# UNITED STATES PATENT AND TRADEMARK OFFICE

APPLICATION NO.	FILING DATE	FIRST NAMED INVENTOR	ATTORNEY DOCKET NO.	CONFIRMATION NO.
10/552,257	10/05/2005	Masahiro Yamamoto	92478-6300	1980
53044 7590 06/23/2010 SNELL & WILMER L.L.P. (Panasonic) 600 ANTON BOULEVARD SUITE 1400 COSTA MESA, CA 92626			EXAMINER SNYDER, ZACHARY J	
			ART UNIT 2889	PAPER NUMBER
			MAIL DATE 06/23/2010	DELIVERY MODE PAPER

# Office Action Summary

### DETAILED ACTION

Applicant's figure is provided below:

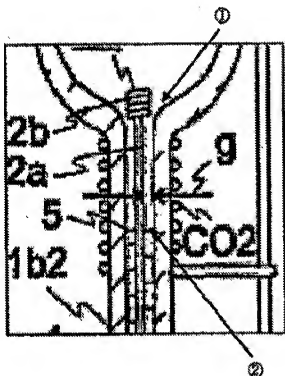
The Examiner agrees with the Applicant that, the section having a greatest curvature of inner surface of the light emitting part would be in the region where gap g is located. However,

the Examiner wishes to note that the radius of curvature would be constant throughout the region where gap g is located, so therefore the section having a greatest curvature of inner surface of the light emitting part could be moved closer to the electrode tip. This is the basis for the rejection provided below.

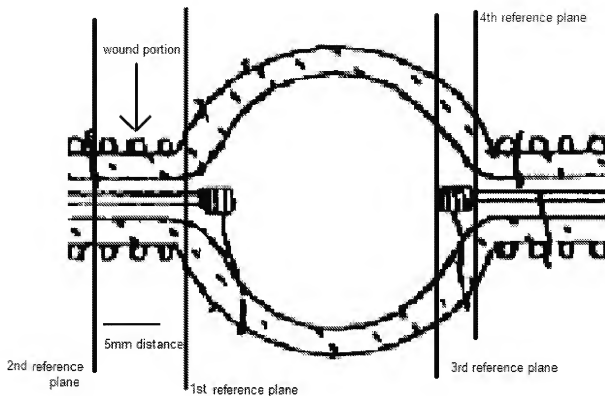
the lead portion is electrically connected to the electrode (junction conductor CC1 is connects the electrode pair and outer lead terminals, paragraph 55), of the pair, positioned nearer the second sealing part (shown in figure 4), and at least a section of the wound portion is wound substantially spirally at least 0.5 turns in a range from a 2<sup>nd</sup> reference plane to a 3<sup>rd</sup> reference plane (shown in figure below), and

a closed loop around one of the light emitting part and the first sealing part does not exist within the range (shown in figure below and figure 4 to see the loop is open), where

the 2<sup>nd</sup> to 3<sup>rd</sup> reference planes are parallel to a 1<sup>st</sup> reference plane lying orthogonal to a bulb longitudinal direction and including an end of the discharge space positioned at a base portion of the electrode nearer the first sealing part (shown in figure below),

the 2<sup>nd</sup> reference plane being distant 5 mm from the 1<sup>st</sup> reference plane (the length of the sealing part is 8mm, paragraph 181, so these reference planes can be chosen to be 5 mm apart) along the first sealing part and the 3<sup>rd</sup> reference plane passing through a tip of the electrode nearer the second sealing part (shown below).

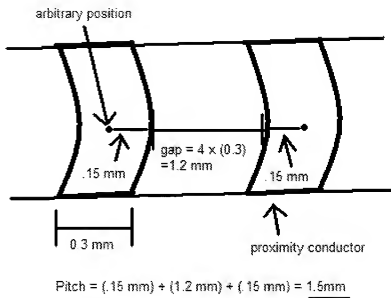
Honda discloses that when the winding pitch of the coil is 500%, a gap four times wider than the diameter of the metallic wire shaping the coils is defined between two adjacent turns (paragraph 92). The diameter of the coil is 0.3 mm (paragraph 186). The figure below shows that the interval pitch as defined by the applicant ("distance in the longitudinal direction from an

arbitrary position on the proximity conductor to a position removed one revolution (360 degrees or 1 turn) from the arbitrary position”) is at least 1.5 mm.
